Date: AUG 01 2017
Symbol: EPC-DO: 17-283
LA-UR: 17-25530
Locates Action No.: N/A

SUBJECT: Transmittal of Class 1 Permit Modification Request to Include Dome 224 within the Los Alamos National Laboratory Hazardous Waste Facility Permit

Enclosures 1: Class 1 Permit Modification Request to Include Dome 224 at Technical Area 54, Area G, Pad 5 within the Los Alamos National Laboratory Hazardous Waste Facility Permit

Figure G.8.1 Technical Area 54, Area G, Pad 5, Outdoor Container Storage Unit Soil Sampling Grid and Additional Sampling Locations

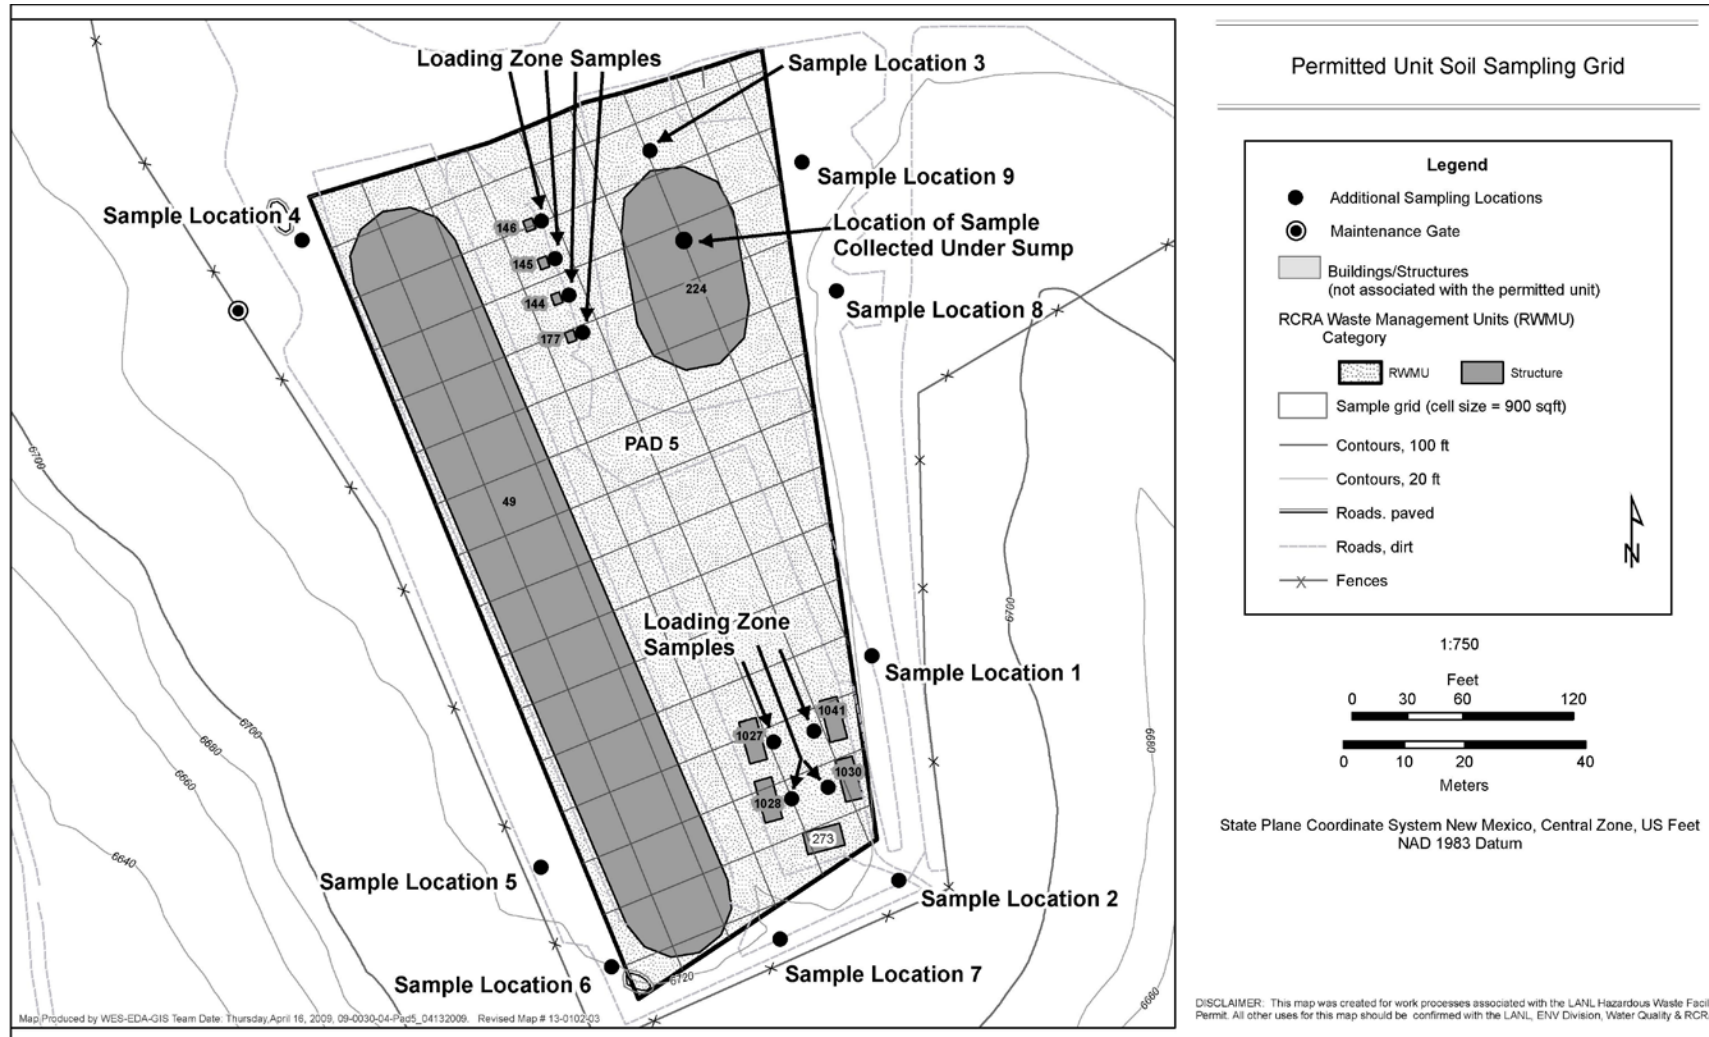
Proposed changes revert to the language within the closure plan as it was prior to the request for removal of the dome from the permitted unit. The description of the dome within Section 2.0, *Description of Unit to be Closed*, was changed to present tense and additions were included in Section 6.1, *Soil Sampling and Decontamination Verification Sampling Activities*. None of the required sample locations have been changed from the approved closure plan, and the Dome 224 footprint has been included on Figure G.8.1: *Technical Area 54, Area G, Pad 5, Outdoor Containers Storage Unit Soil Sampling Grid and Additional Sampling Locations*.

Figure G.8-1 illustrates these sampling locations.

Figure G.9-1: Technical Area 54, Area G, Pad 6 Outdoor Container Storage Unit Sampling Grid and Additional Sampling Locations

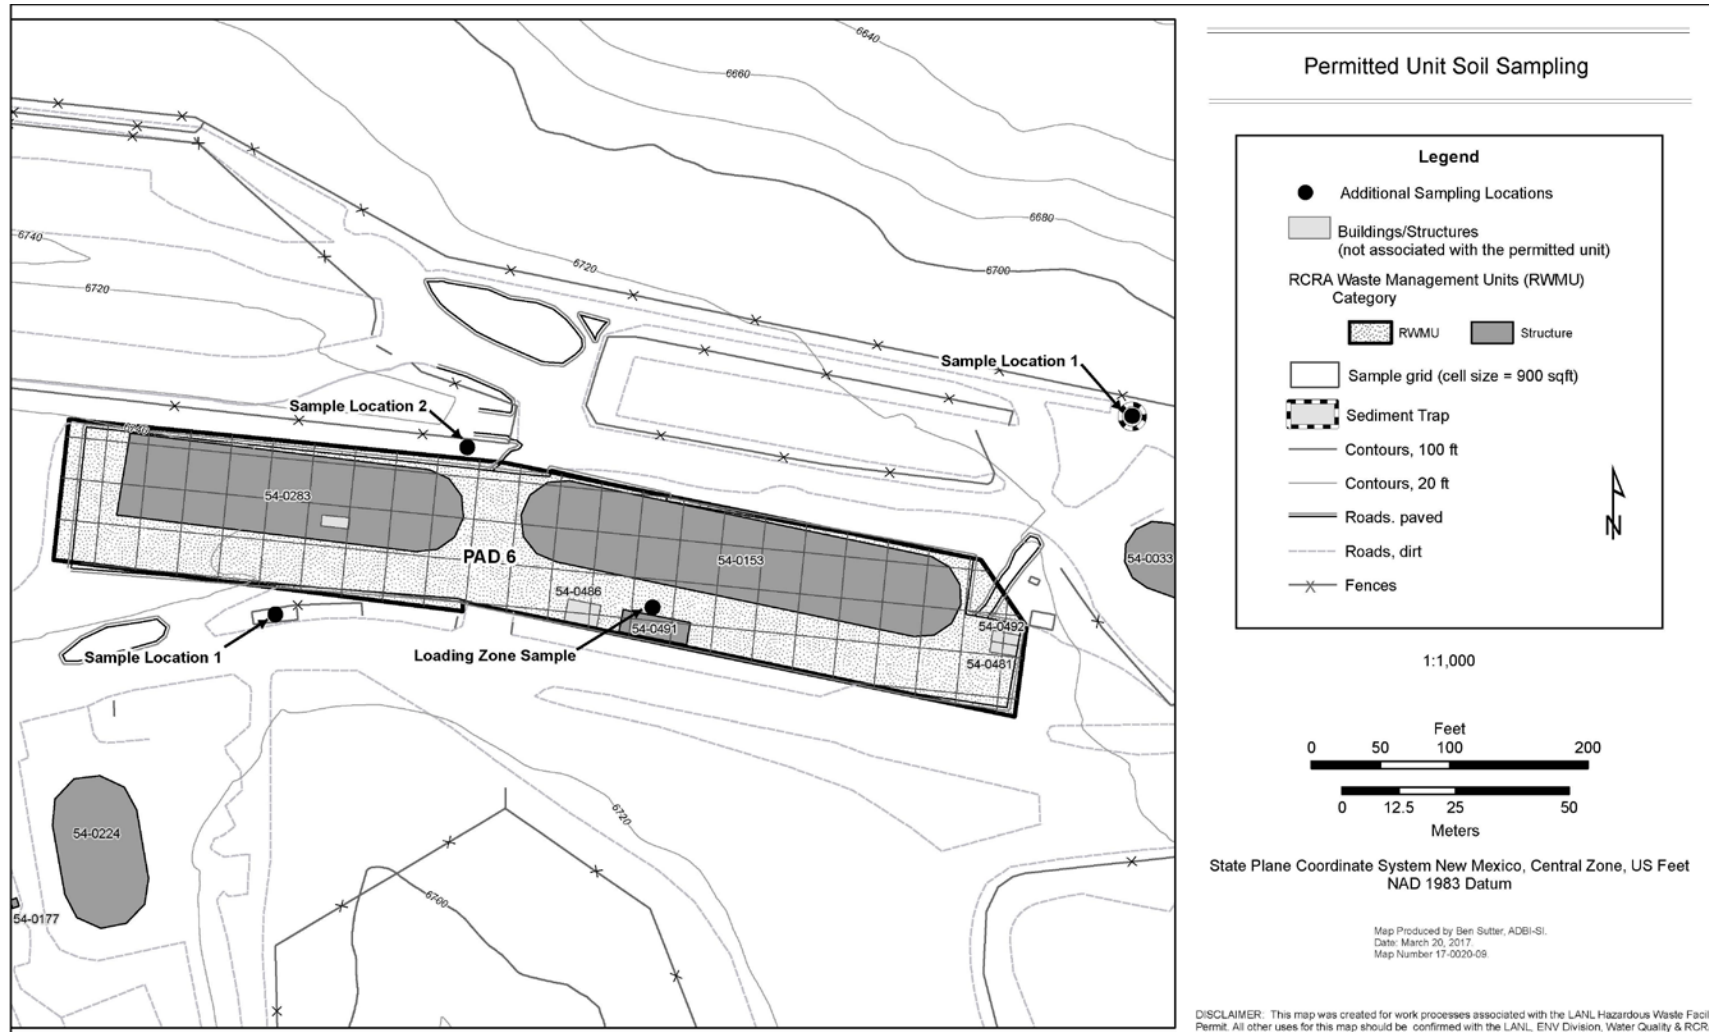
Figure G.9-1: *Technical Area 54, Area G, Pad 6 Outdoor Container Storage Unit Sampling Grid and Additional Sampling Locations* has been revised to include Dome 224 at Technical Area 54, Area G, Pad 5.

Figure 8: Technical Area 54, Area G, Security Fences, Entry Gates, and Entry Stations

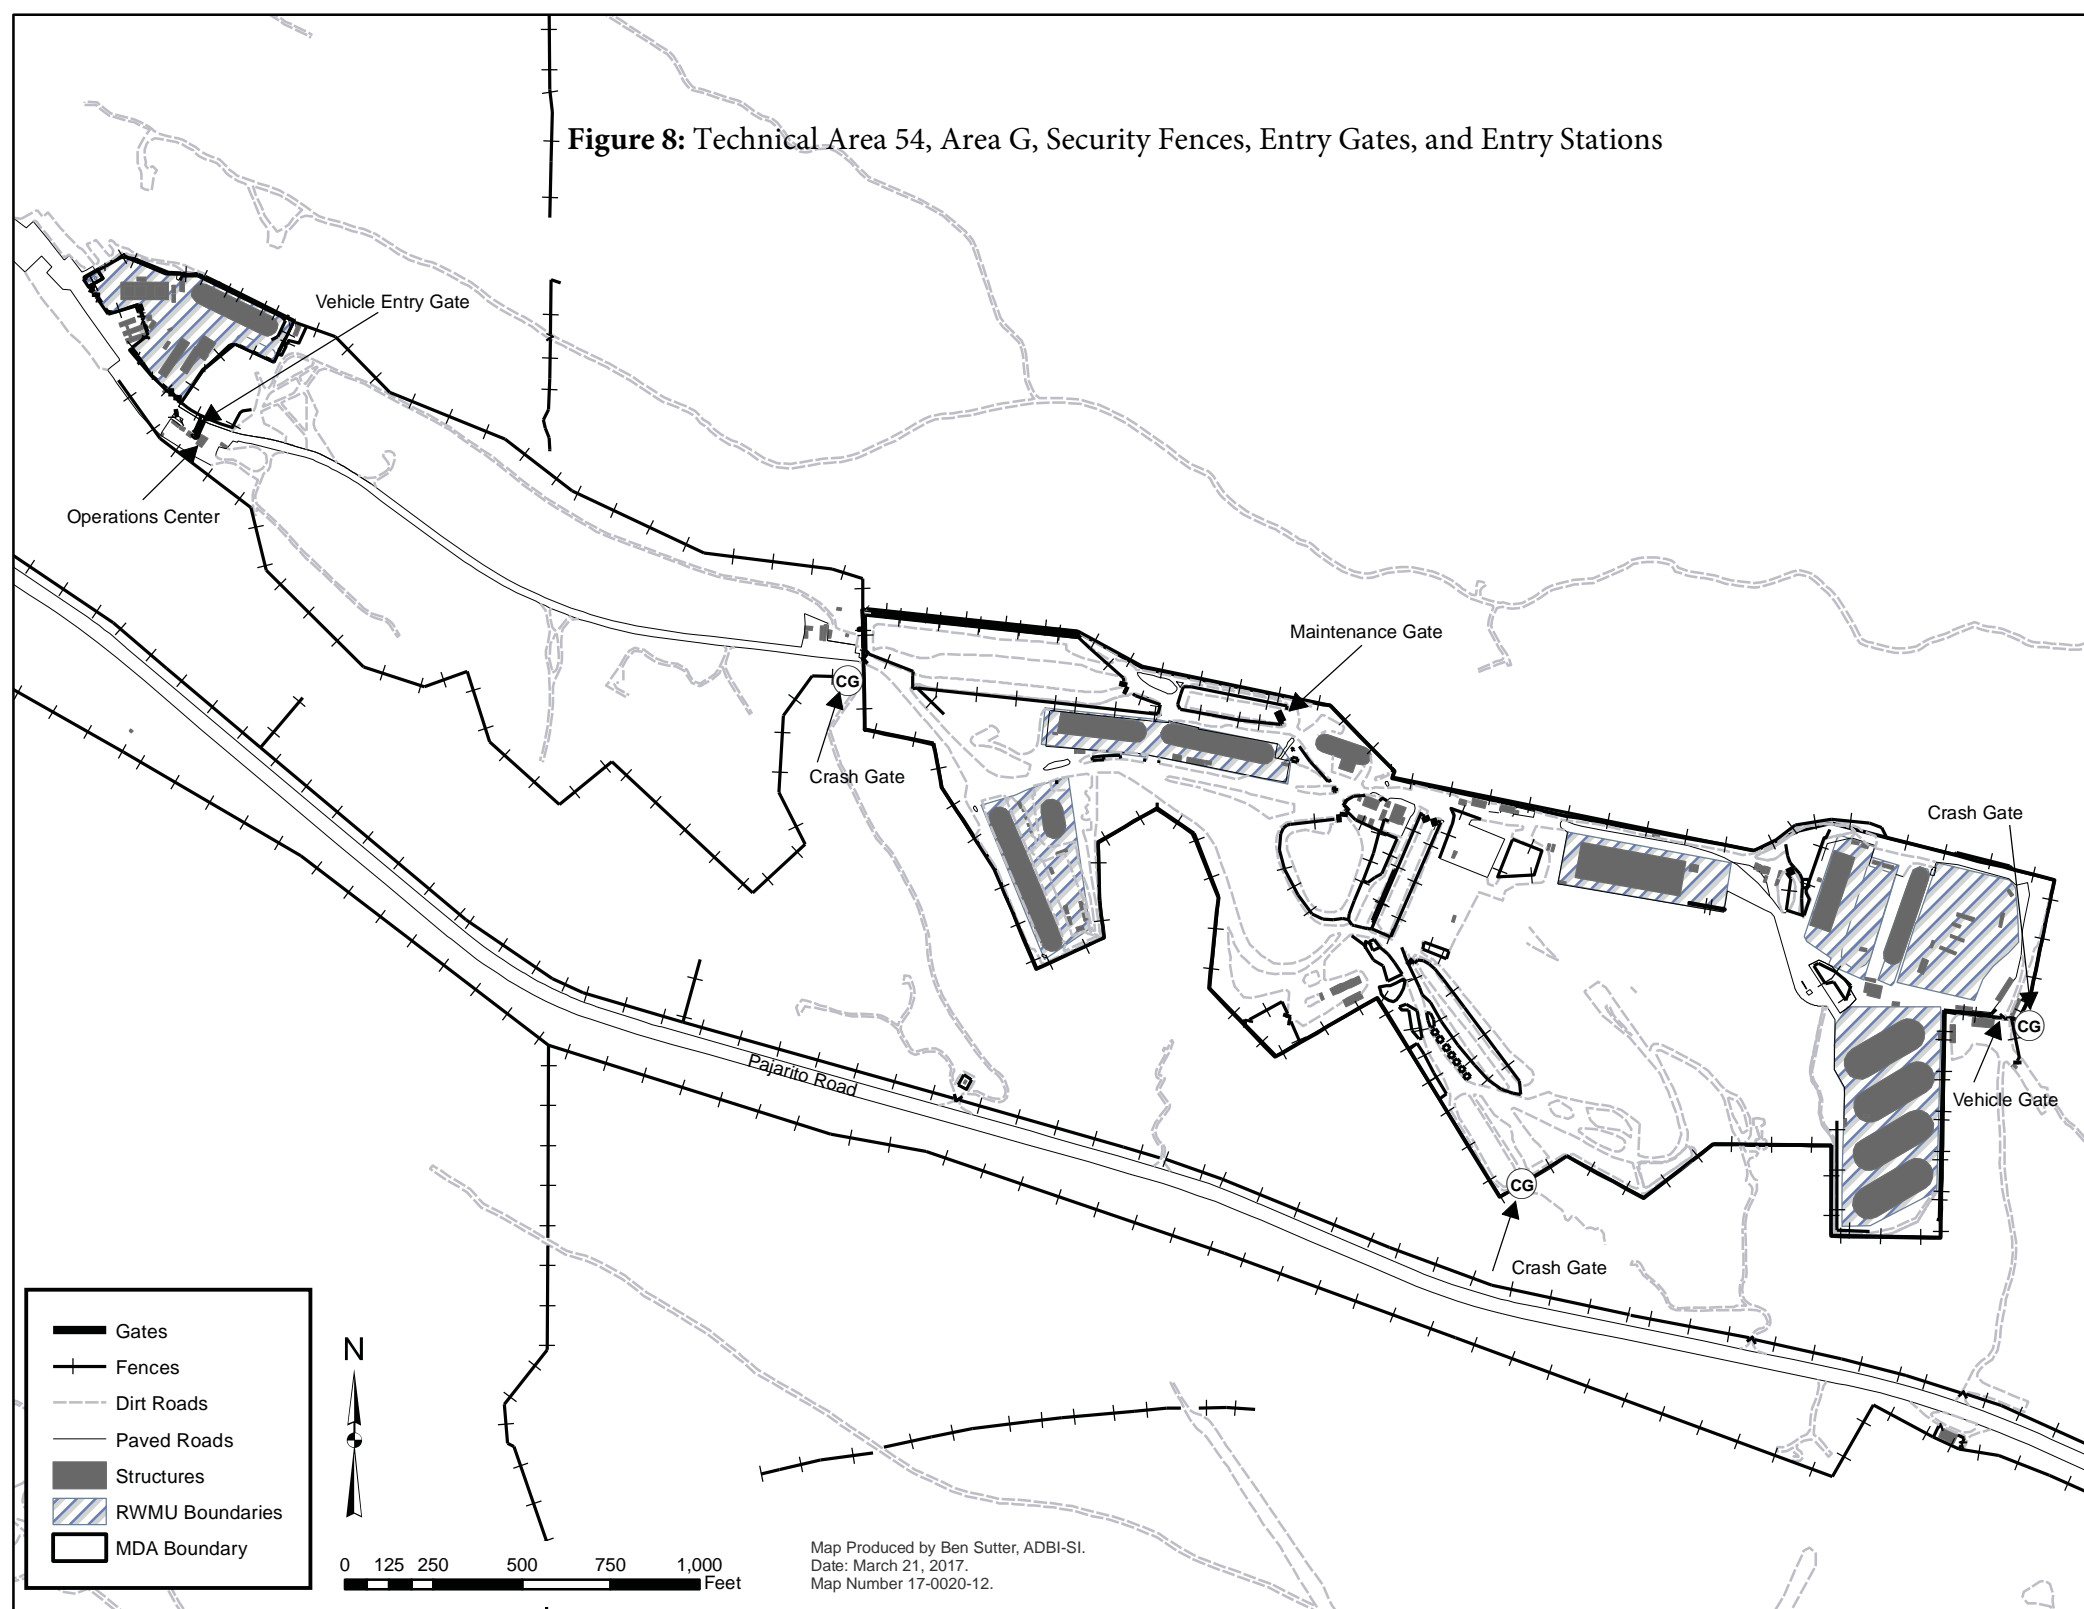
Figure 8: *Technical Area 54, Area G, Security Fences, Entry Gates, and Entry Stations*; Figure 27: *Technical Area 54, Area G, Container Storage Units*; and Figure 33: *Technical Area (TA)-54, Area G, Pad 6, (Domes 153 & 283)* were revised to include Dome 224. Also, Figure 32 within Attachment N was revised to include the Dome 224 structure on the permitted unit and the title of the figure was changed to “Figure 32: Technical Area (TA)-54, Area G, Pad 5 (Domes 49 and 224; and Storage Sheds 114, 145, 146, 177, 1027, 1028, 1030, and 1041)”.
